stm32-blinky — Design Document

Board review: stm32-blinky (P8 adversarial pass)

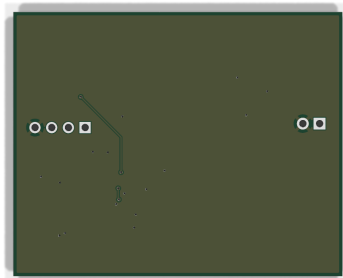
ERROR 1 - J1 power input has no polarity legend on silk (requirements miss)

requirements.md sec 2 and architecture/blocks.md both promise the 5 V input "polarity marked on silkscreen" (J1 pin 1 = +5 V, pin 2 = GND). The as-built board has NO text or +/- legend anywhere: silk carries refdes only (there is not a single gr_text on the board). What exists at J1 is a pin-1 dot and a square pad (see crop-j1_d1.png) - and the dot sits on the header body outline,

so after the header is soldered the plastic covers it. Post assembly the top side shows nothing but "J1"; the square pad is visible only from the bottom.

Consequence: the unkeyed 2-pin input can be plugged backwards with no on-board hint. D1 (series SS34) prevents damage - reversed input just does not conduct - but the user gets a dead board and no way to know why or which way is right without opening the design files. This is the board's primary human interface and an explicit requirements promise. Fix is two silk texts ("5V", "GND" or "+", "-") next to the holes, outside the header body. Must fix before fab; there is ample empty silk area (left region is empty).

WARNING 1 - J2 SWD pins unlabeled (architecture promise miss)

`blocks.md` promises "Canonical pin order (silk-labeled): 1 = SWDIO, 2 = SWCLK, 3 = 3V3, 4 = GND". Electrical order verified correct from the netlist (pads: SWDIO/SWCLK/+3V3/GND, U1 PA13/PA14 to pins 1/2). But there are no labels - only a pin-1 square cell (`crop_d2_j2.png`) which the header body covers after assembly. ST-Link clones are wired pin-by-pin; swapping 3V3/GND shorts the debugger's 3.3 V rail to ground. Same trivial fix as ERROR 1 (four small silk texts below the header row - the area under J2 is clear). Strongly recommend fixing together with ERROR 1; warning rather than error only because `requirements.md` itself demands the ORDER (met), the labels are an architecture-level promise.

WARNING 2 - refdes association ambiguity (cap cluster + C3-under-J2)

- "C11" text sits directly above R1's body; "C1" text below-left of R1; "C7"/"C8" labels float between parts they do not touch. Among these 0603s are four DIFFERENT cap values (22 pF, 10 nF, 100 nF, 1 uF) plus a 1 k resistor - a hand-rework or debug probe guided by silk has a real chance of landing on the wrong part.
- "C3" text renders directly under J2 pads 3-4 and reads like a header label (its own body is 3.6 mm away). Mildly reinforces the J2 labeling problem: someone may read "C3" while counting SWD pins.

- EMI/robustness: no RF, no switcher on board (antenna/keepout hunt: N/A). Crystal Y1 is mid-board, 6.9 mm from the nearest edge, over continuous B.Cu GND pour; return-path check green. One deliberate oddity reviewed: C7 (OSC_IN load cap) sits at the MCU end, 12.6 mm from Y1 pad 1 (crop_xtal.png) while C8 hugs Y1 pad 2 - unconventional, but the 8 MHz Pierce loop rides a solid pour, the HC-49S itself is 11.5 mm long, and F103 HSE drive has wide margin. ACCEPT as-is (no board change); noting it so nobody "fixes" it into a worse route later.

Assembly itself is CPL-driven, so production risk is nil; consequence is limited to bench rework/debug confusion. WAIVER RECOMMENDED for rev A - but since ERROR 1 forces a silk edit session anyway, nudging these labels onto their parts at the same time costs minutes.

- WARNING 2 (refdes ambiguity): waive for rev A if the silk session from ERROR 1 is not extended to labels - rework-only consequence.
- /VIN pdn:false opt-out: endorse permanently (see triage 1) - it is the electrically correct treatment, not a suppression.
- Architecture outline text 35x30 vs built 50x40: accept or one-line doc fix.

NOT waivable in this reviewer's judgment: ERROR 1 (J1 polarity legend) - explicit requirements promise, primary user interface, zero-cost fix.
